Access Compliance Report Public Rights-of-Way (Curb Ramps)

Intersection ID: N/AMain Street: E_4TH_STCross Street: N/ALocation:EADA ID: DC6A1E31C6EERamp Type: PerpInitial Pass/Fail: FailOverall Compliance: NoSeverity Score: 37.5

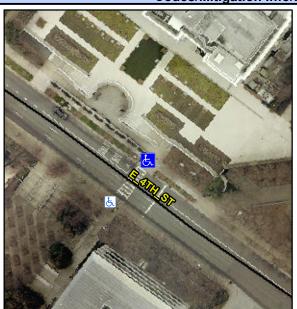
R304.2.2, R304.5.3

Field Measurements/Component Compliance					
Compliance Description		Data	Comp	oliance Description	Data
N/A	Ramp Length (in)	68.0	No	Ramp Slope (%)	14.3
Yes	Ramp Width (in)	51.0	No	Ramp XSlope (%)	6.0
N/A	Flare Type LT	N/A	N/A	Flare Type RT	N/A
N/A	Flare Slope LT (%)	N/A	N/A	Flare Slope RT (%)	N/A
N/A	Flare Traversable LT?	No	N/A	Flare Traversable RT?	No
N/A	Landing Length (in)	N/A	N/A	DWS Provided?	N/A
N/A	Landing Width (in)	N/A	N/A	DWS Contrast?	N/A
N/A	Landing Slope (%)	N/A	N/A	DWS Length (in)	N/A
N/A	Landing X Slope (%)	N/A	N/A	DWS Full Width?	N/A
N/A	Landing Curb? (Y/N)	N/A	N/A	DWS Offset (in)	N/A
N/A	Shared Landing?	N/A			
N/A	Gutter Ponding?	N/A	N/A	Gutter Slope (%)	N/A
N/A	Gutter Lip Ht (in)	N/A	N/A	Gutter X Slope (%)	N/A
N/A	Painted X Walk1?	Yes	N/A	Painted X Walk2?	N/A
	X Walk 1 Direction	To SW		X Walk 2 Direction	N/A
N/A	X Walk 1 Width (in)	109.0	N/A	X Walk 2 Width (in)	N/A
	X Walk 1 Slope (%)	5.5		X Walk 2 Slope (%)	N/A

Remove & Replace Entire Ramp.
